EMORANDUM

FROM: Stephen Cochran, Case Manager

DATE: November 3, 2015

SUBJECT: BZA No. 19103 – Area Variance and Special Exception relief requested for construction of a new building at 901 5th Street, NW – Square 516, Lot 59

Figures 1 and 2. Site and locations for which Closed Court; Rear Yard, and Parking variances are requested

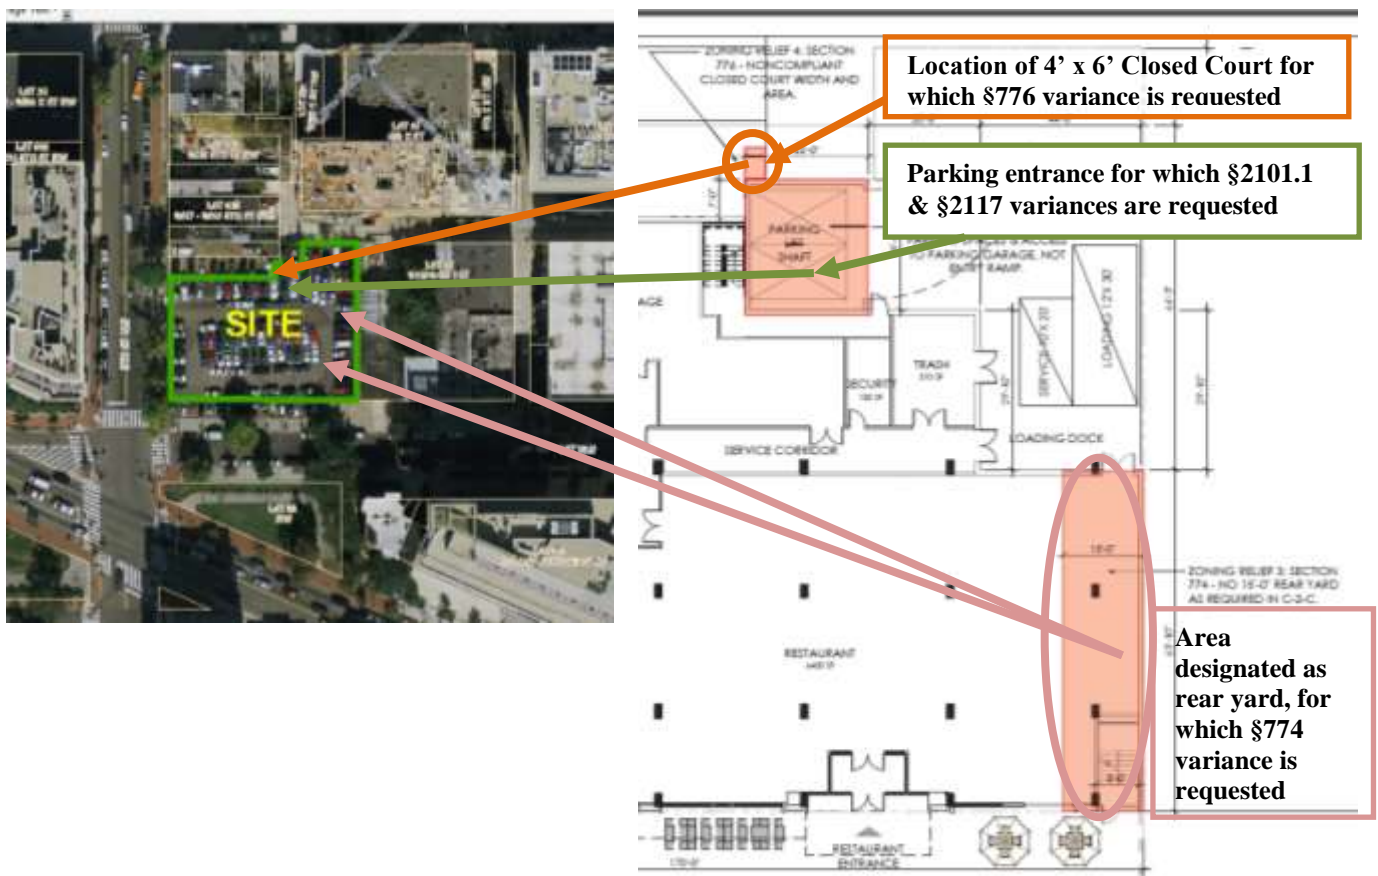
The applicant has demonstrated that the site's relatively small size for a downtown location and its irregular northern boundary results in a practical difficulty in meeting the requirement to provide a rear yard on this lot, particularly given the core-factor requirement for the desired mixed use development.

The applicant has demonstrated that with 5th Street being considered the front of the building, the provision of a rear yard to the east would result in a 15 foot wide and 130 foot tall gap in the streetwall on I Street. The site is a corner property within the Mount Vernon Triangle historic district (the historic district) and the Mount Vernon Triangle sub-area of the Downtown

The applicant has demonstrated that the unusual shape of the northern lot line would lead to a practical difficulty in meeting the closed court regulations were strictly applied. For a 4 foot wide section of the northern lot line, the boundary jogs 6 feet deep into the lot to the north. It would be impractical to fill in this 24 square foot area to the building's height of 130 feet. It would result in either a solid block of construction material or an unusable interior space that would be approximately 2 feet wide, 5 feet deep and 130 feet high. The alternative -- provision of an 884 square foot, 130 foot high closed court open to the air -- would negatively impact the interior layout of the ground floor open air and would create an unusable and difficult to maintain exterior space when the property to the north is developed and an additional wall is created for the court.

Figure 3. Roof Structure Relief

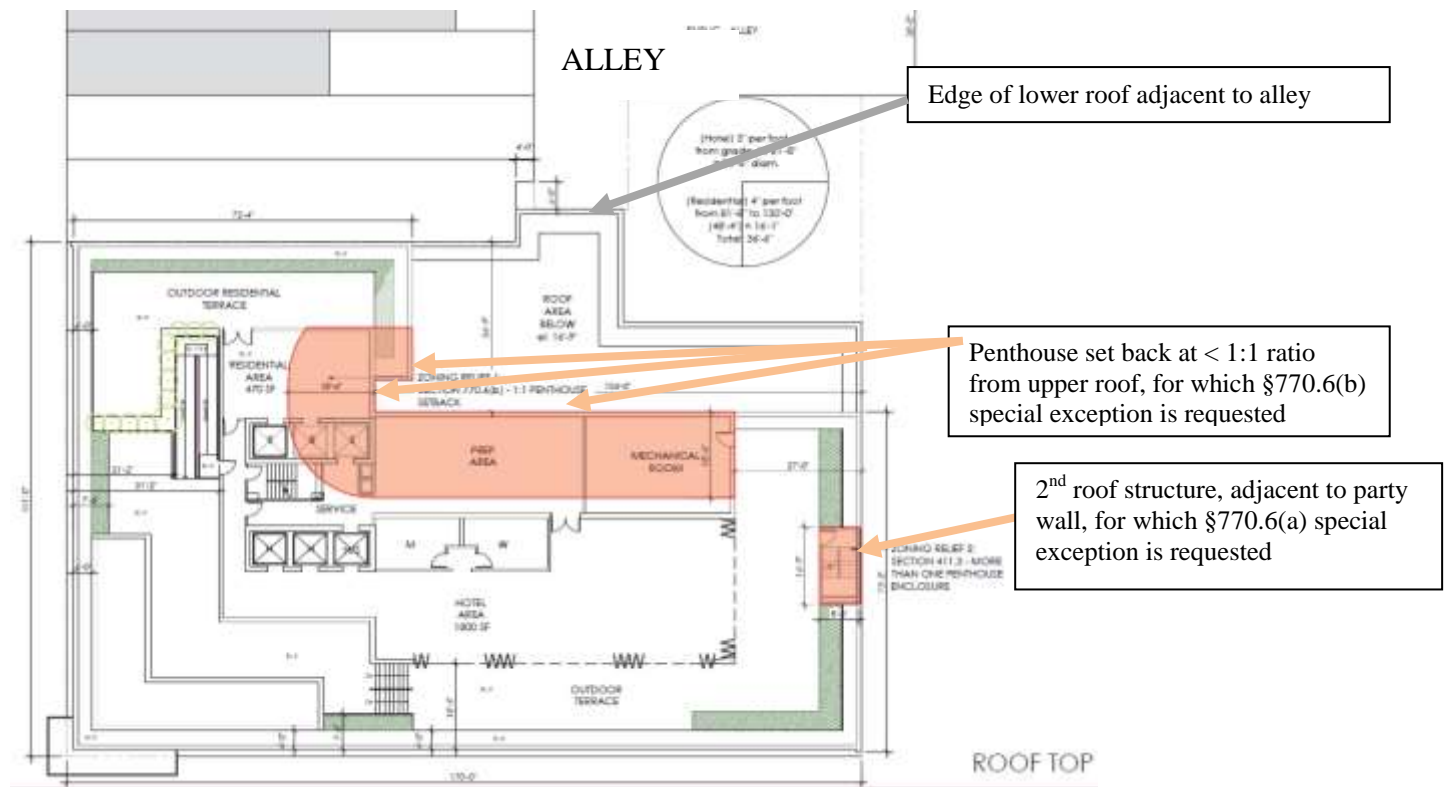
Yes. The applicant has demonstrated that the additional roof structure is necessary to meet code requirements for secondary egress from a roof deck providing access for recreational or other purposes and that requiring it to be connected to the principal roof structure would result in the loss of green roof and in an increased mass for the roof structure.

Yes, the applicant has demonstrated that full compliance would result in operating difficulties and unreasonable modifications to the building plans. The applicant's architectural drawings illustrate that providing a 1:1 setback from the northern wall of the top story of the building would require the relocation of the elevator core, which would negatively impact corridor widths and parking aisle widths on the western side of the building, reducing the number of hotel rooms and parking spaces that could be provided, and potentially reducing the number of two-bedroom units.

No. Granting the requested relief for the addition would not impact the light and air of adjacent buildings. The side property line of the nearest building to the north would be at least 37 feet from the edge of the proposed roof structure.

No. The Zoning Administrator has determined that the exterior walls on the north side of the building consist of the walls that are closest to, but removed from, the northern property line. These walls are located in the northwestern portion of the site and are illustrated on pages 13 and 14 of the architectural drawings submitted with the applicant's pre-hearing statement. The walls from which the applicant has requested setback relief are approximately 37 feet back from these exterior walls. Granting setback relief from what the Zoning Administrator has determined, under the current regulations, to be non-exterior walls would not materially impair the intent and purpose of the zoning regulations and would further the efficient layout and use of the proposed building.
